ALERT SERVICE BULLETIN

NO. 205-02-87

MODEL AFFECTED: 205A-1

SUBJECT: TAIL ROTOR BLADE ASSEMBLIES P/N 212-010-750-011 / -113 / -115, INSPECTION AND REWORK OF.

FIGURE 1

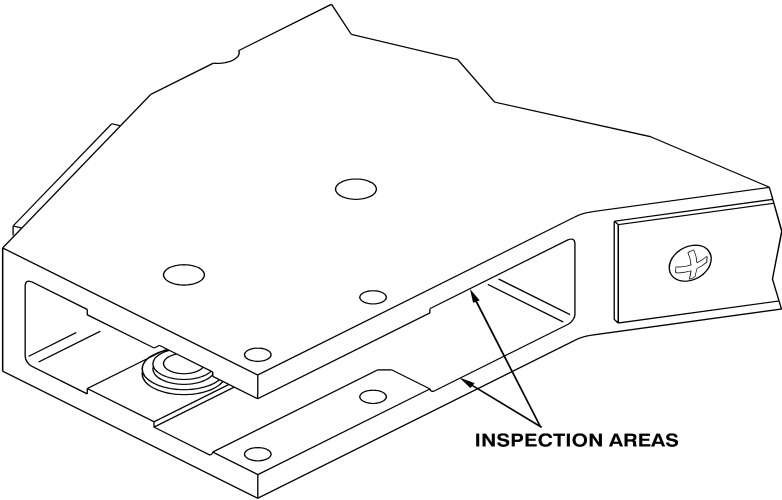
Bell Helicopter has discovered that certain serial number tail rotor blades may have been manufactured with mechanical damage located on the inside of the root cuff. The mechanical damage may be identified on the inside of the upper and lower grip plates. The exact location varies, but generally located outboard of the outboard blade bolt attachment hole. See figure 1 and 2.

1. Ensure that the location of each tail rotor blade is identified in relation to the hub assembly. Ensure that all hardware and balance weights are identified so they can be reinstall at the same location.
2. Remove tail rotor blades from helicopter. Refer to Bell-205A-1-MM for instruction.
3. Remove pitch horn from blade. Refer to Bell-205A-1-CR&O manual for instruction.
4. Clean off all paint inside blade cuff areas per figure 1 and 2.
 - a. Remove paint by sanding with 120 grit abrasive cloth or paper (C-423)
 - b. Clean residual paint with an abrasive pad (C-407) and Methyl-Ethyl-Ketone (C-309) or alternate.
 - c. Wipe area with a clean cloth dampened with alcohol (C-339)
5. Inspect area for mechanical damage.
6. If a defect is found, perform a penetrant inspection of the grip plates to ensure that no cracks are present.

7. Blend any damage found to a maximum depth of 0.030 inch (0.762 mm). Blend over a length of at least 10 times the depth on all edges of the damage.
8. Surface finish of repair shall be similar to surrounding area.
9. Apply chemical film (C-100) to reworked area.
10. Refinish tail rotor blade assembly per Bell-205A-1-CR&O.
11. Install pitch horn
12. Install tail rotor blade assemblies on aircraft.
13. Annotate records to indicate compliance with this bulletin.

FIGURE 2

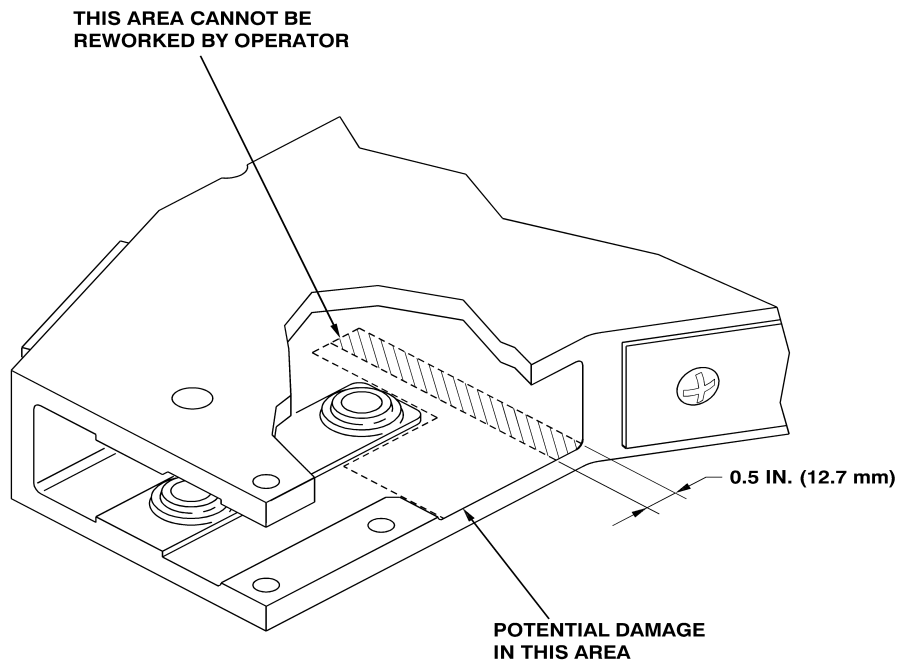
If the depth of the damage exceed 0.030 inch (0.762 mm) or the damage is located in the non-reparable area per figure 2, notify Product Support Engineering for further instruction.
